Planning & Zoning Board Meeting

- 2.** Consideration and Recommendation: **Venezia Townhomes Final Subdivision Plan Review**

TO: Howey-in-the-Hills Planning Board
CC: J. Brock, Town Clerk, S. O'Keefe, Town Administrator
FROM: Thomas Harowski, AICP, Planning Consultant
SUBJECT: Venezia Townhomes Final Subdivision Plat
DATE: January 20, 2022

TO: Howey-in-the-Hills Development Review Committee
CC: J. Brock, Town Clerk; S. O'Keefe, Town Administrator
FROM: Thomas Harowski, AICP, Planning Consultant
SUBJECT: Venezia Townhomes Final Subdivision Plan
DATE: January 4, 2022

C602

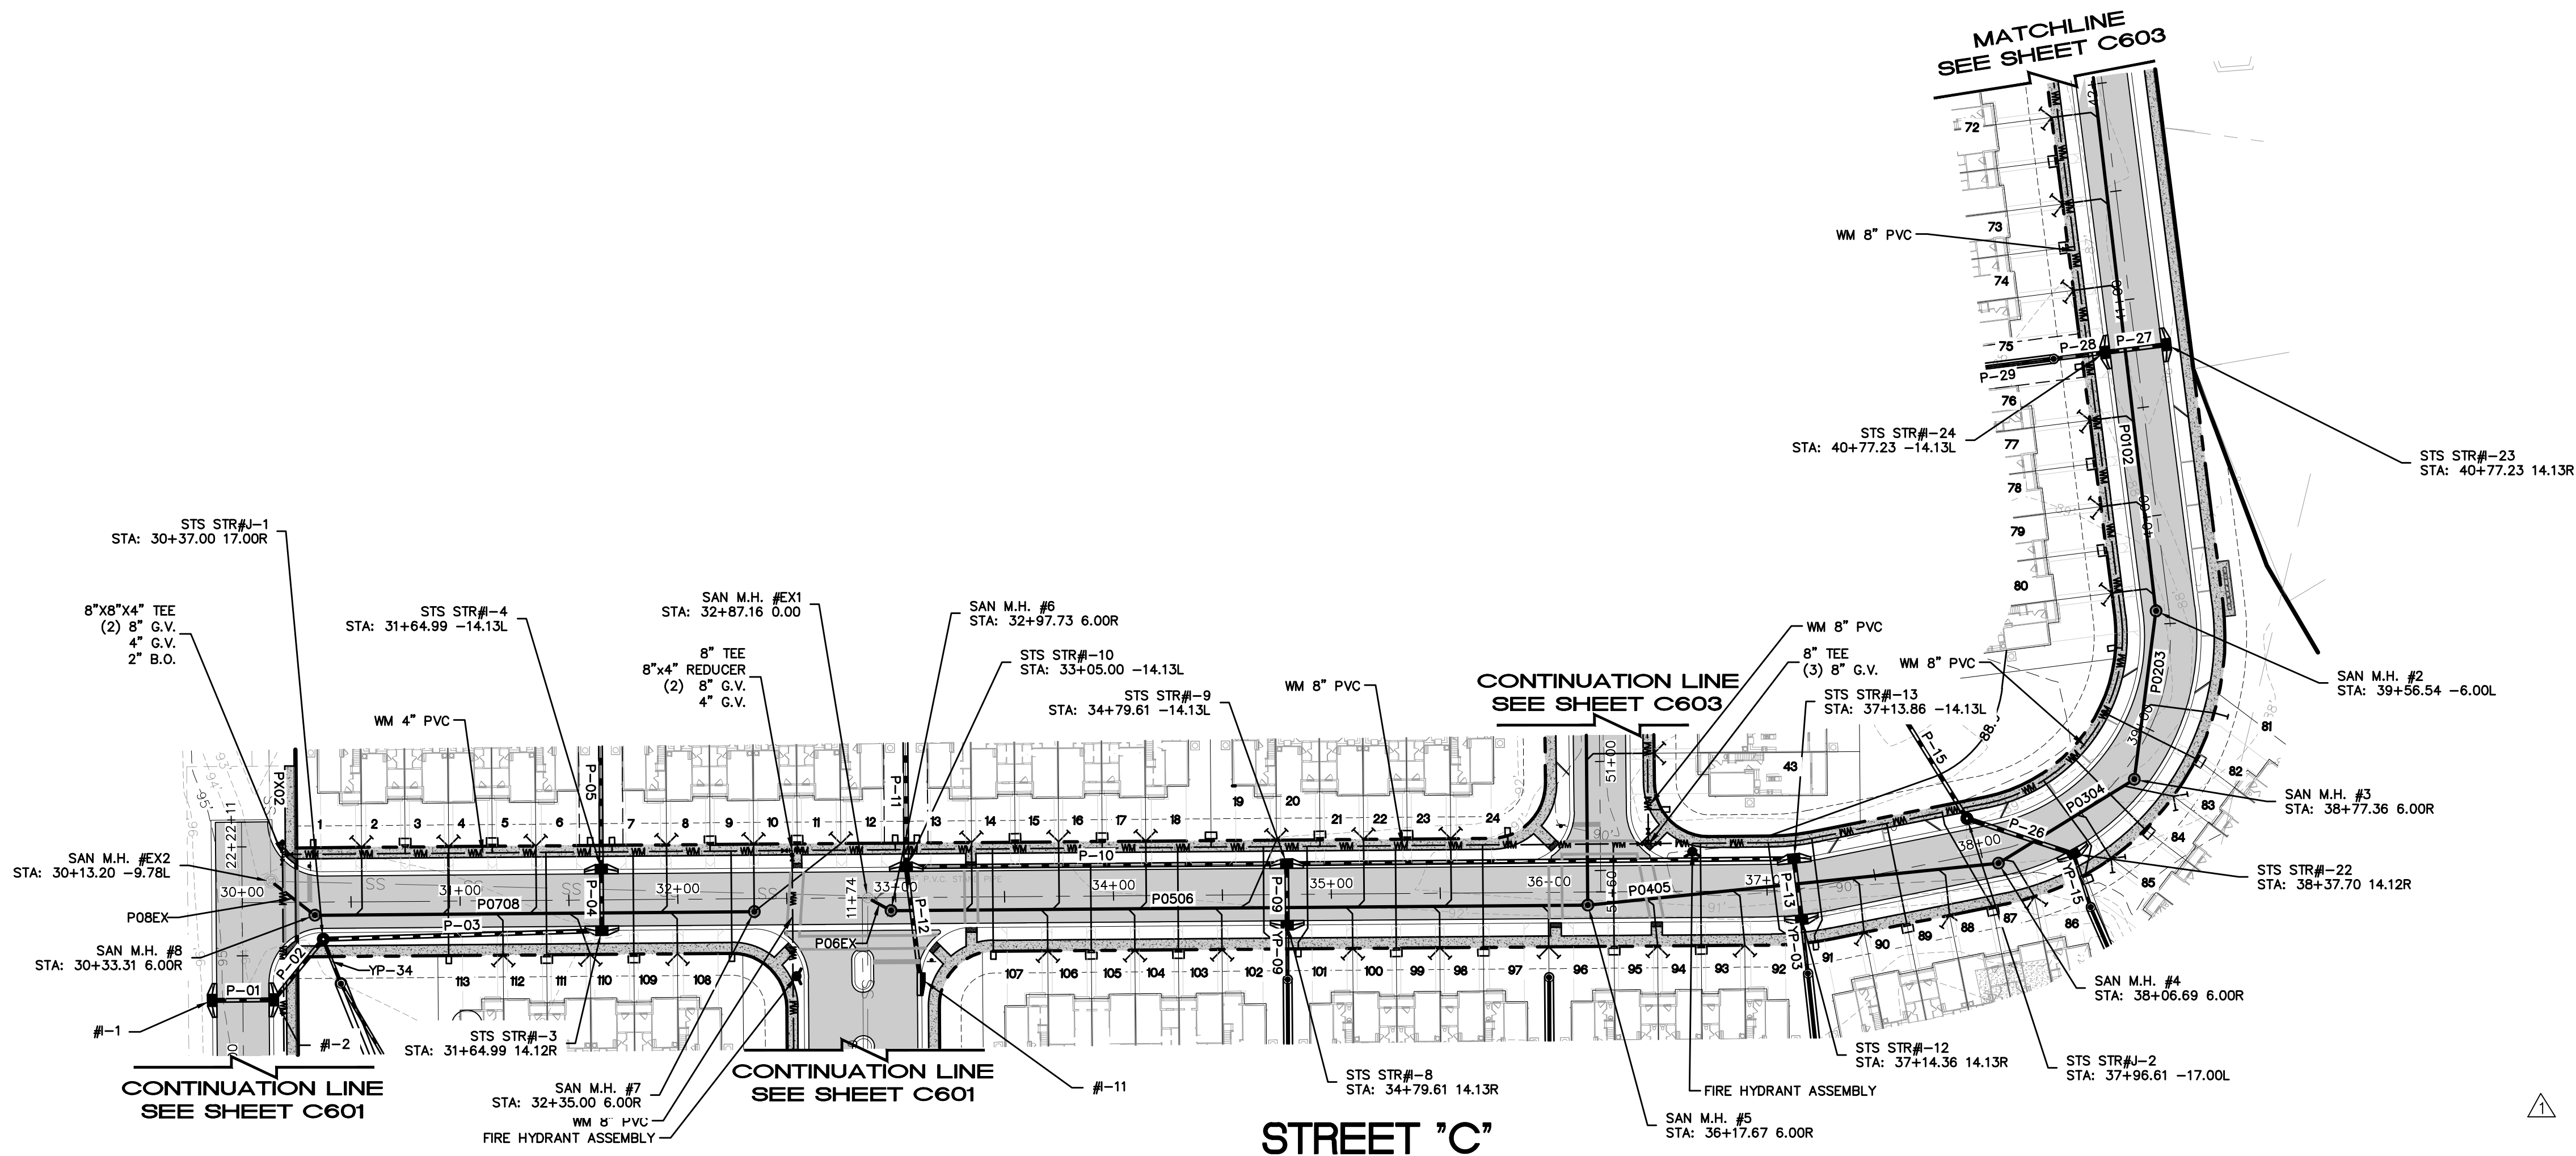
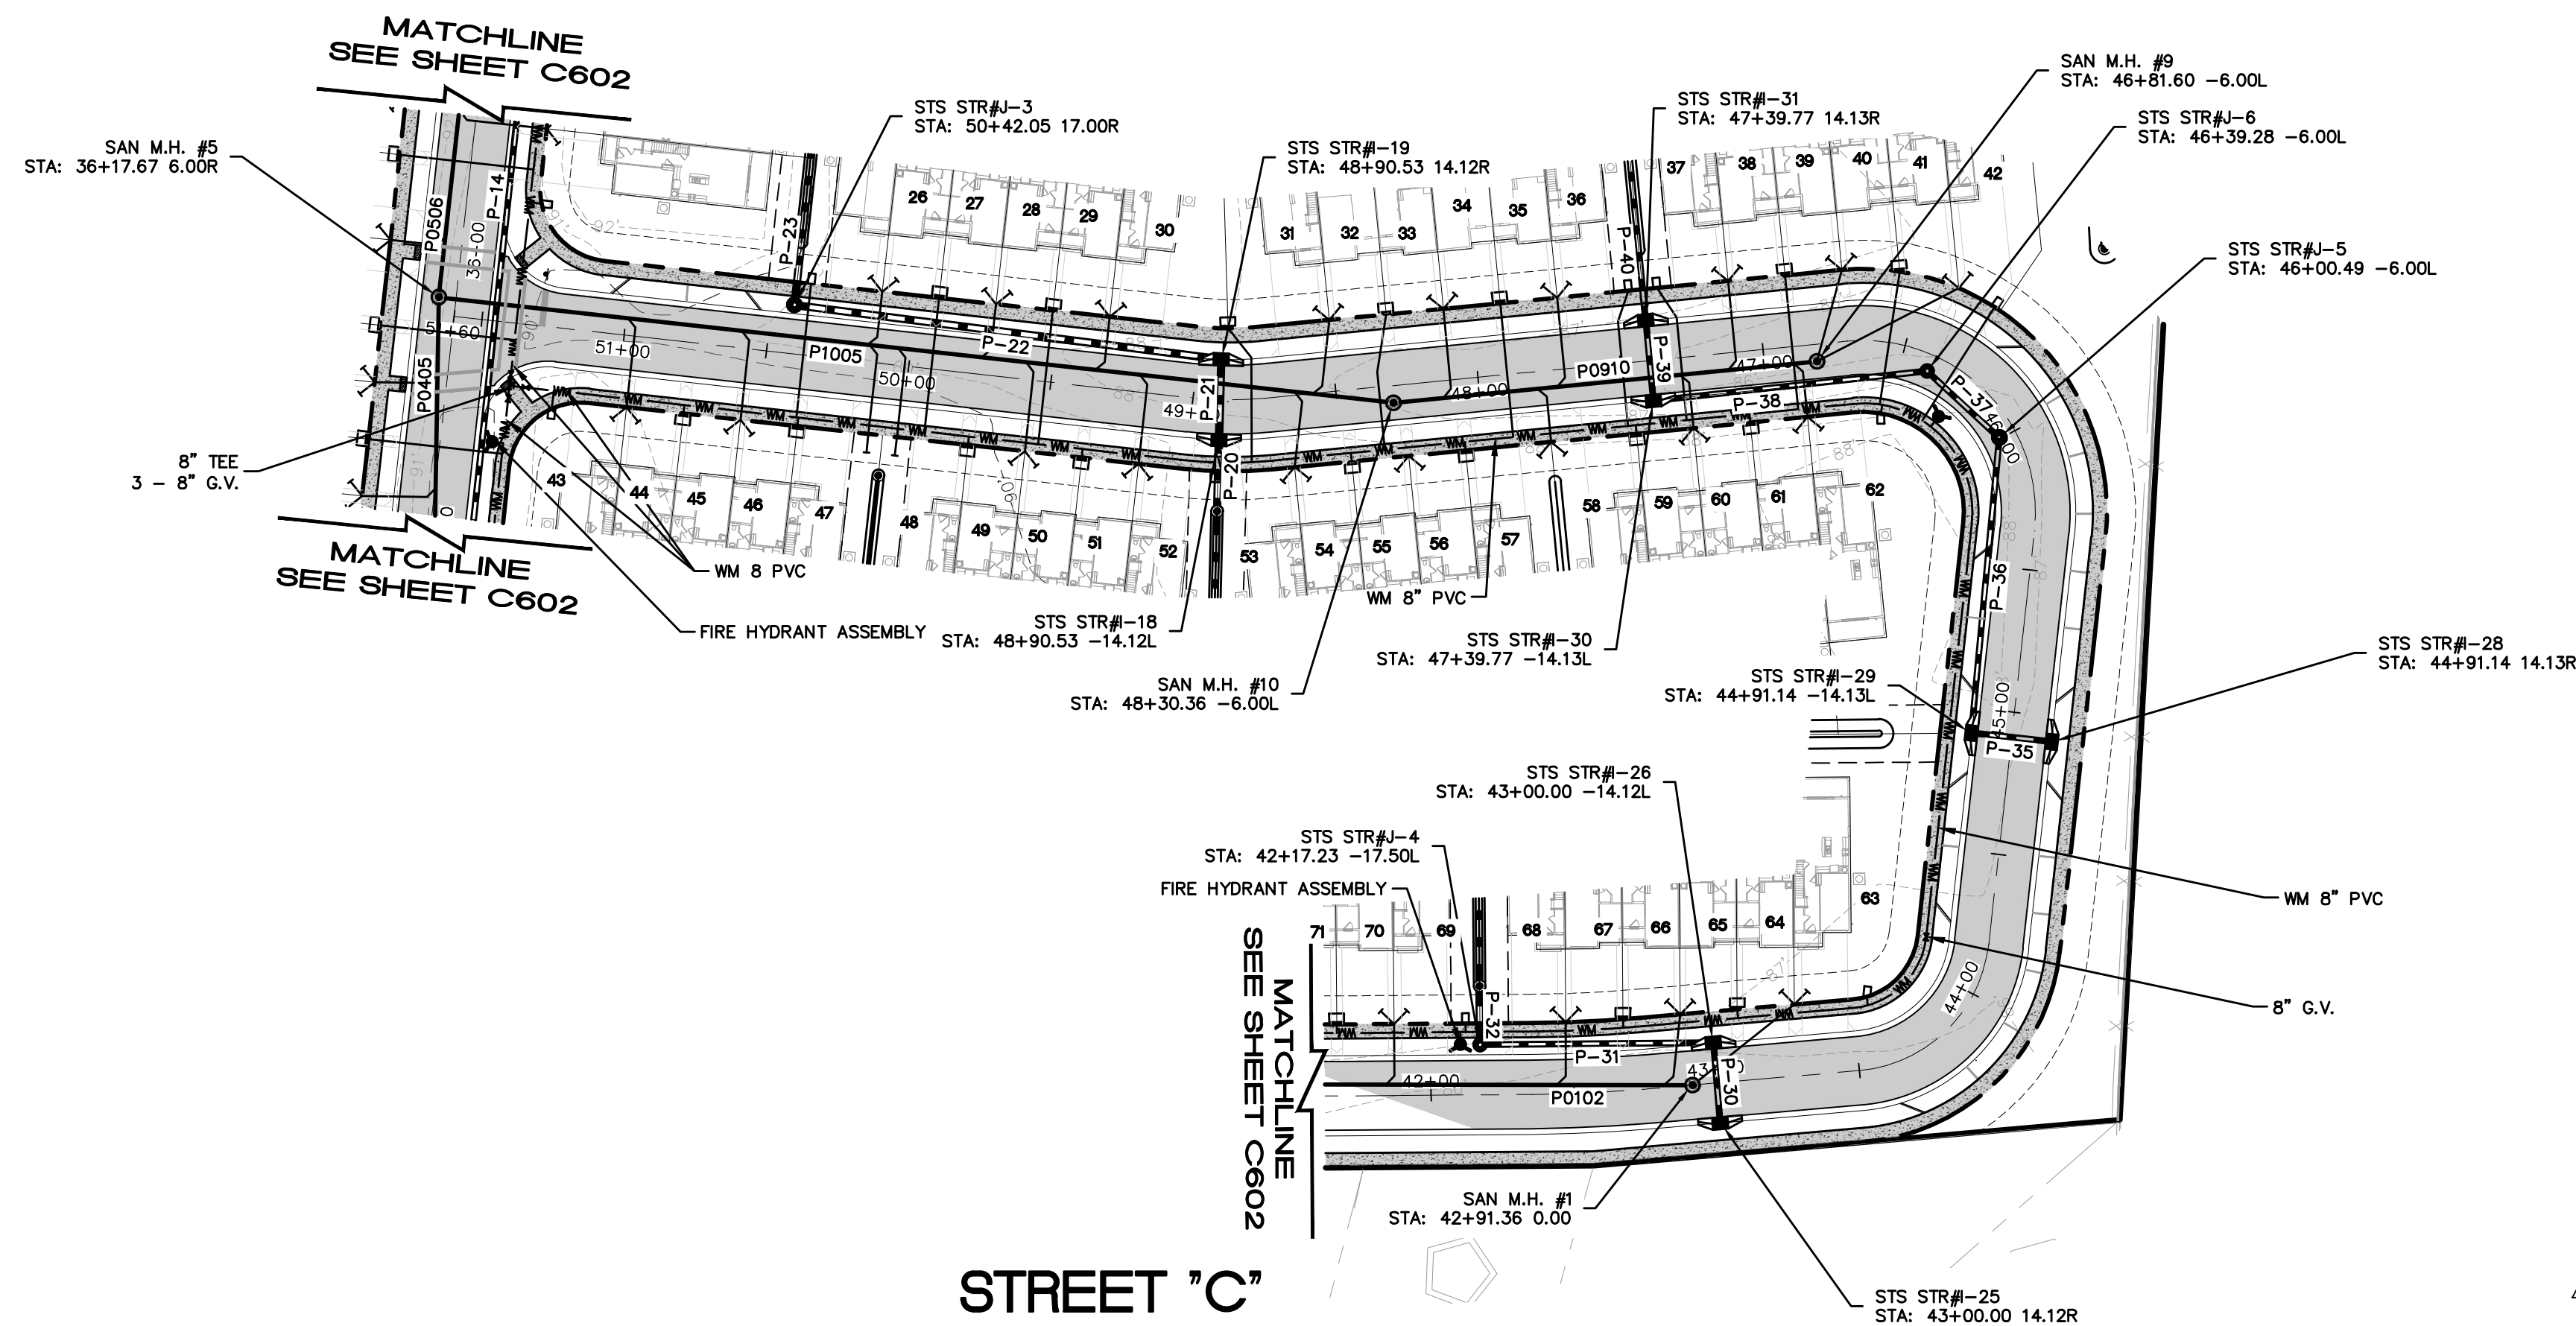
Comment 4: On the profiles for Streets "B" & "C" (C601 & C602) correct the depiction of the sewer tie-in for the outside drop connections.

Response: Per discussion at DRC the added drop manhole detail on Sheet C912 is sufficient.
